Certificate of Appropriateness

Filing Date: March 12, 2024
Case Number: **24-09-HPC**
Request: **Certificate of Appropriateness**
Project Address: 908 Rutherford Street, Shreveport, LA 71104
Historic District: Fairfield Historic District
Zoning: R-HU
Applicant: Clarence Babineaux, SGB Architects, LLC
clarence@sgba.com
MPC Review by: Peiyao Li, Community Planner I
peiyao.li@shreveportla.gov
HPC Meeting Date: March 19, 2024

The applicant would like permission to "construct new colonnade that connects the existing colonnade at the school to the north wall of the Cathedral and will enclose the 'The Family Garden,' which is the courtyard bounded by the Cathedral, the Parish House, and the School." ²

Figure C. Proposed Site Plan

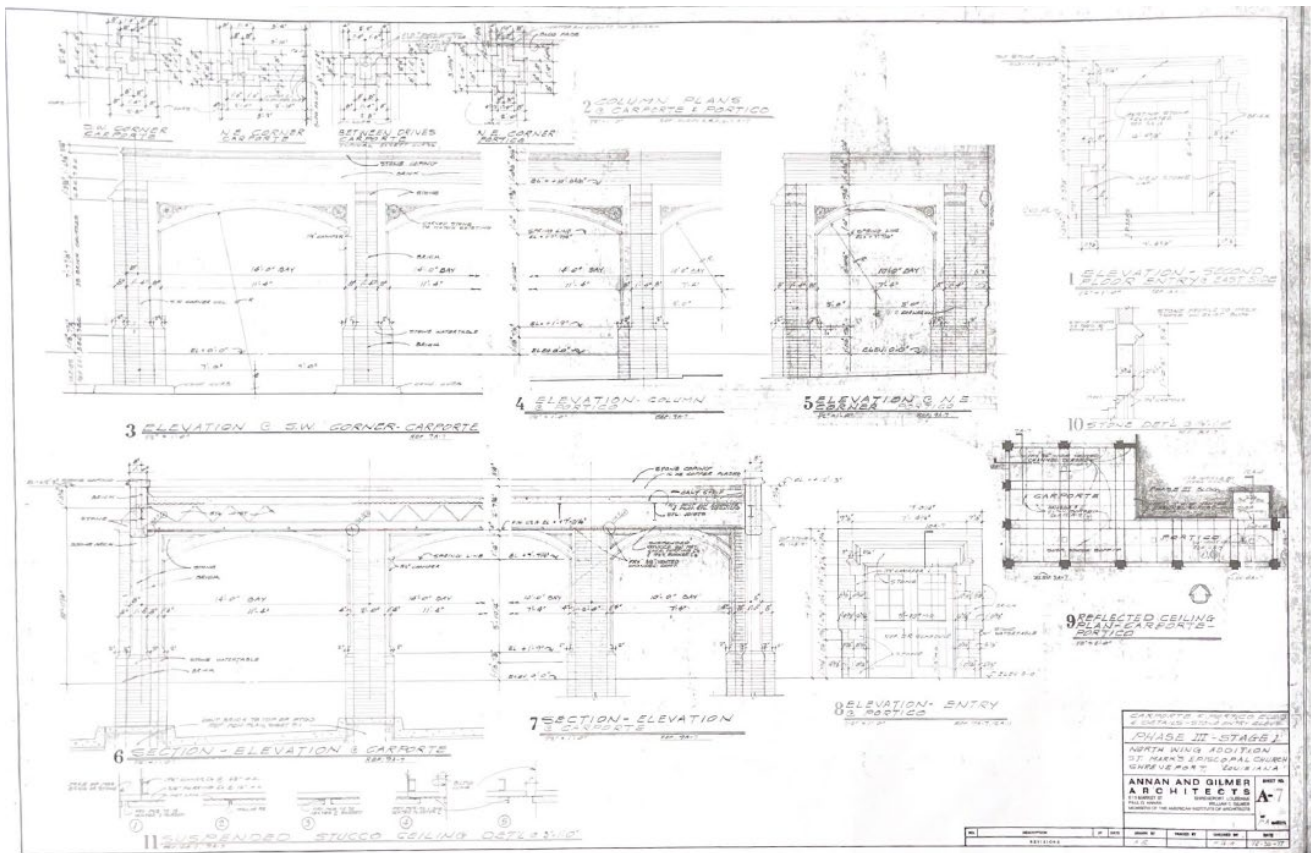
MPC STAFF COMMENTS: MPC staff finds that the proposed improvements are HARMONIOUS with the special character of the HPOD. The proposed colonnade will match the style and color of the existing colonnade. See Figures 1-6 for existing site photographs; See Exhibit C for Proposed Site Plan; See Exhibit D for Proposed Floor Plan; See Exhibit E for Proposed Elevations.

MPC STAFF COMMENTS: MPC staff finds that the proposed improvements WILL NOT adversely affect the historic character of the landmark, site, building, structure, landscape, and/or object. The proposed colonnade will match the style and color of the existing colonnade. See Figures 1-6 for existing site photographs; See Exhibit C for Proposed Site Plan; See Exhibit D for Proposed Floor Plan; See Exhibit E for Proposed Elevations.
